Re: Response to 2nd Technical Notice of Deficiency Letter – Major Permit Amendment Application
Fort Worth C&D Landfill
Fort Worth, Tarrant County, Texas
MSW Permit No. 1983E
Tracking No. 28325020

NOD1 Table - Permit Type IV (Permit 1983E)

**FORT WORTH C&D LANDFILL
TARRANT COUNTY, TEXAS
TCEQ PERMIT NO. MSW-1983E**

MAJOR PERMIT AMENDMENT APPLICATION

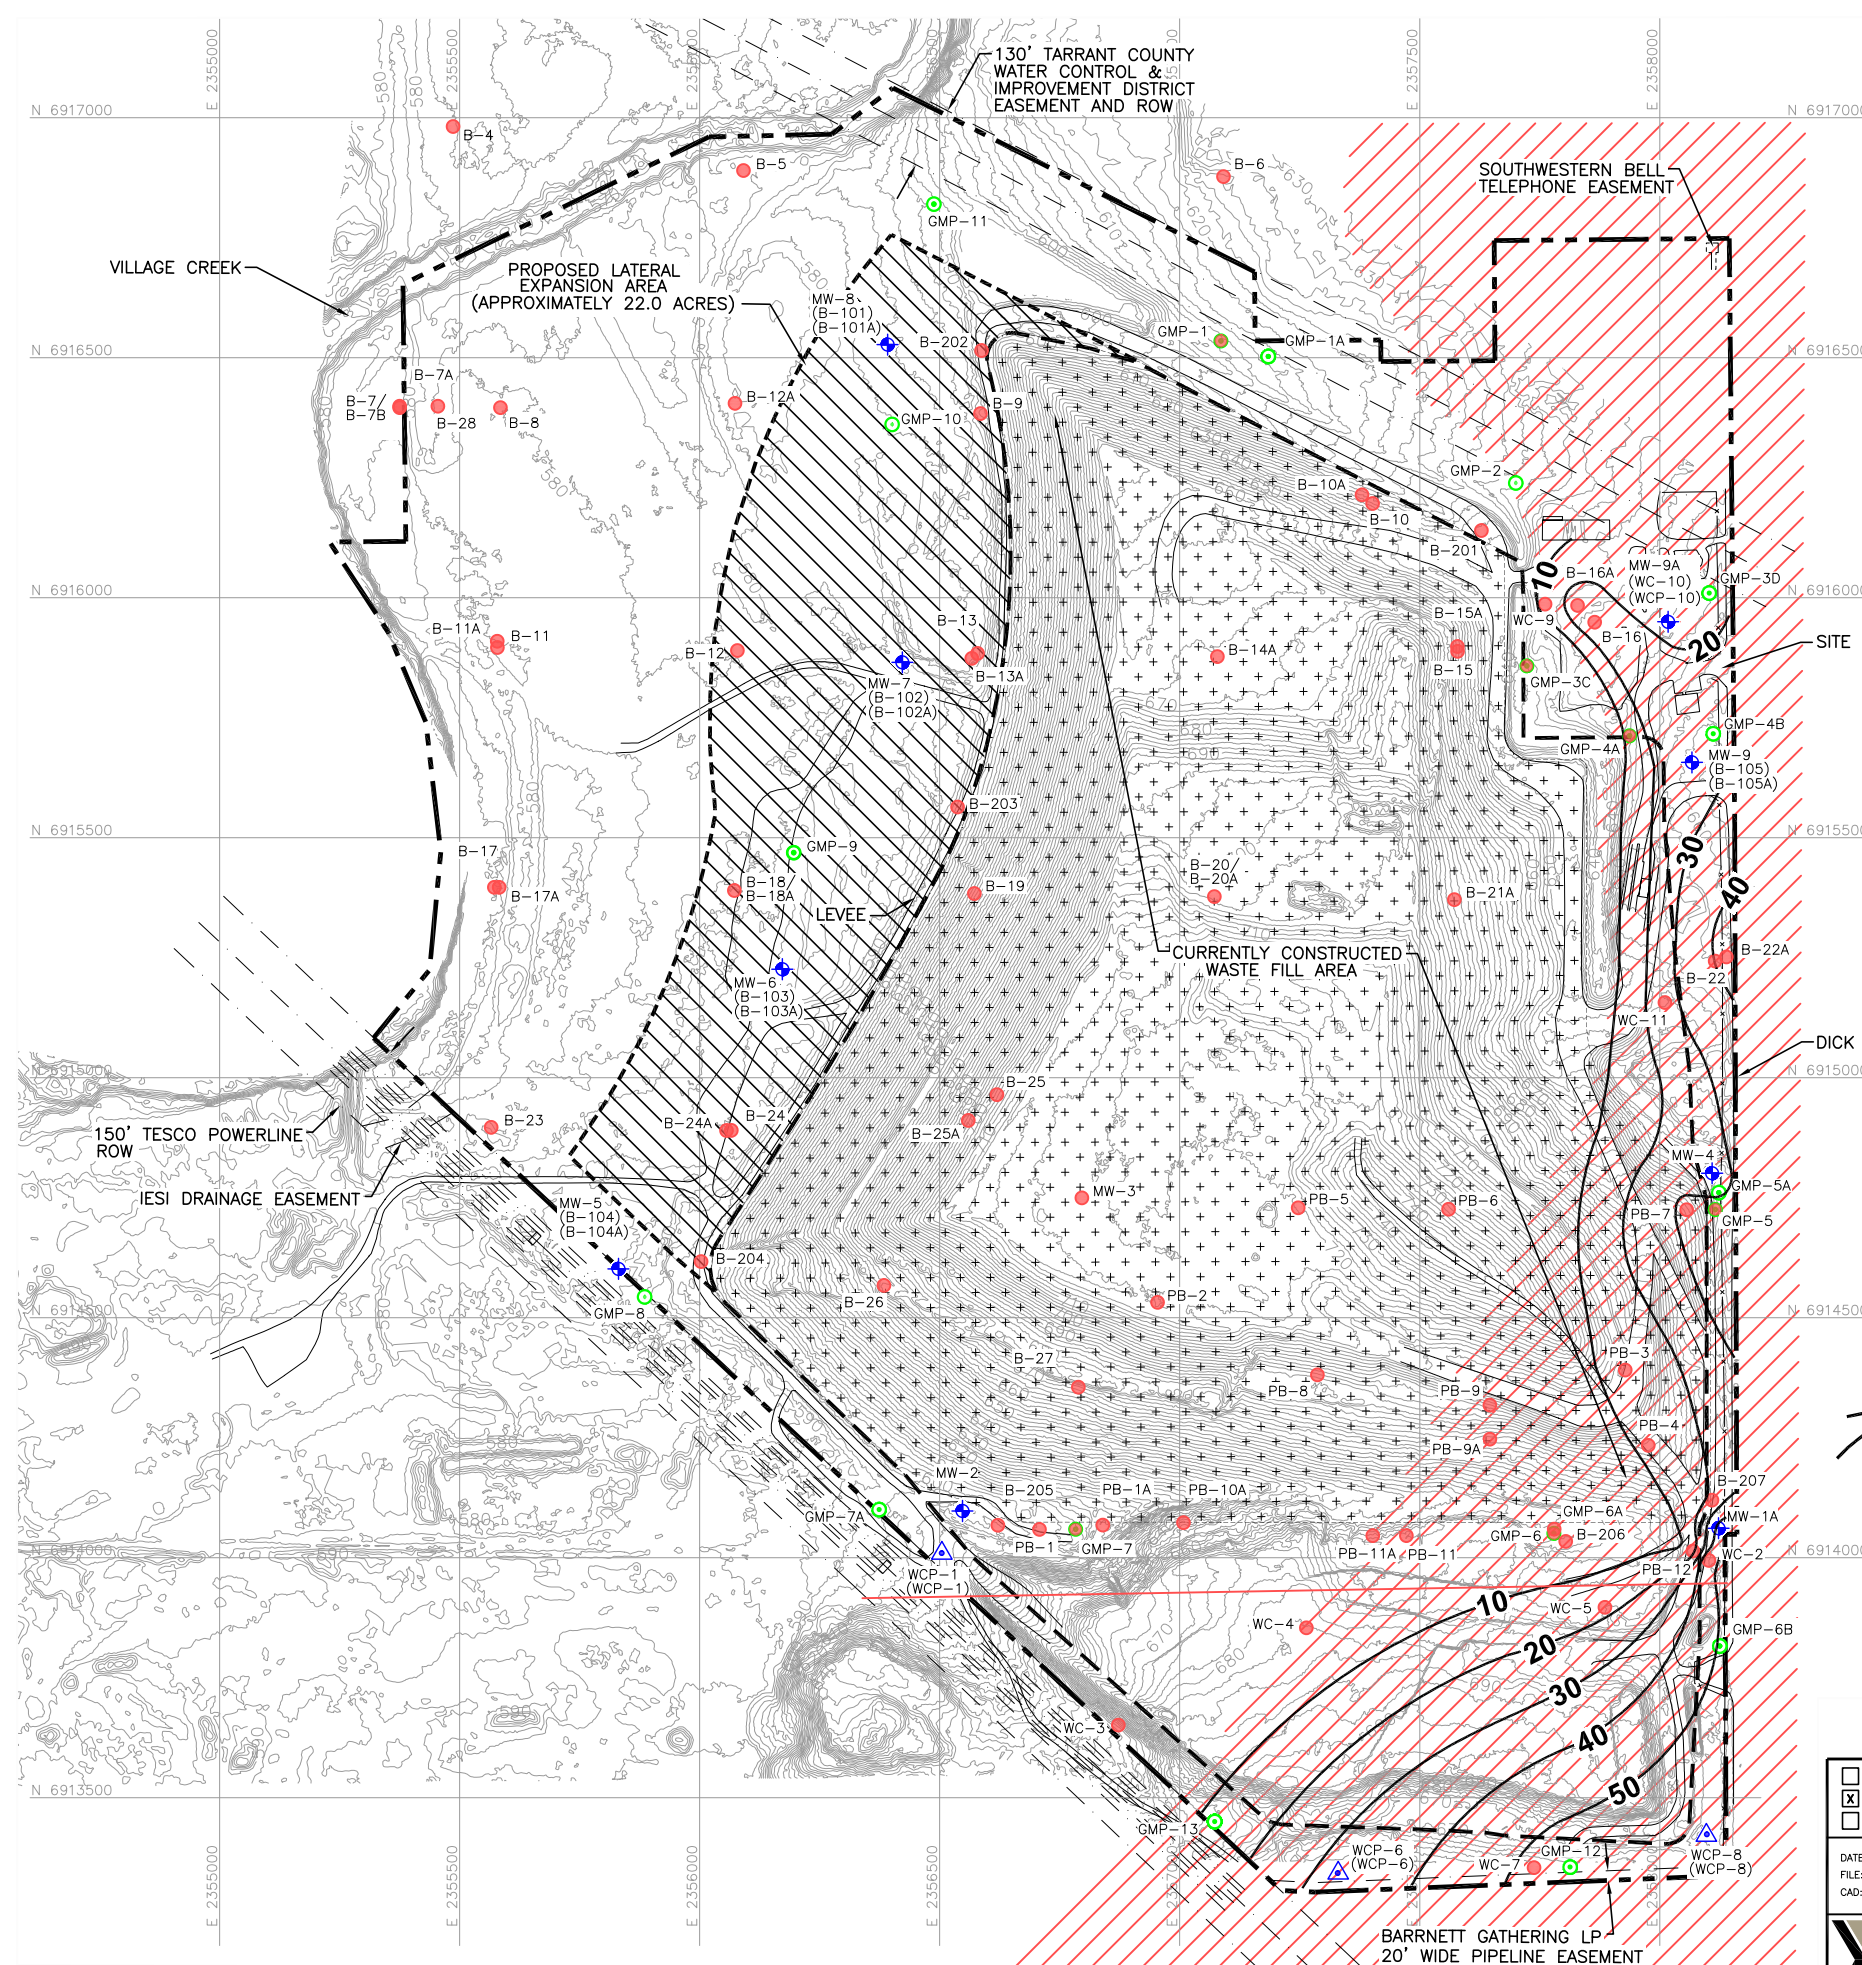
T6	495	Part III	330.63(e)(4)(H)	Incomplete	<p>Provide an isopach map of the Woodbine formation as interpreted from the site investigation.</p> <p>Response: As requested, Figure IIIG-C-34 (Woodbine Formation Thickness Isopach Map) has been added to Appendix IIIG-C.</p>
T7	504	Part III	330.63(e)(5)(C)	Omitted	<p>Submit, if in table format, groundwater levels in all borings, sitewide: the information will consist of depths where water was first encountered as well as records of after equilibrium measurements.</p> <p>Submitted Tables 4-1&2 show historic groundwater elevations in piezometers and monitoring wells. Provide groundwater level in all borings in table format.</p> <p>Response: Per our discussion on August 2, 2023, the requested tabulated historical water level data was provided in the response to the first NOD (NOD ID T27) in June 2023. The water level data provided in Table 4-1 and Table 4-2, and the water level data provided as excerpts on pages IIIG-D-39 through IIIG-D-42 in Appendix IIIG-D, collectively comprise the historical sitewide groundwater level data for the facility.</p>
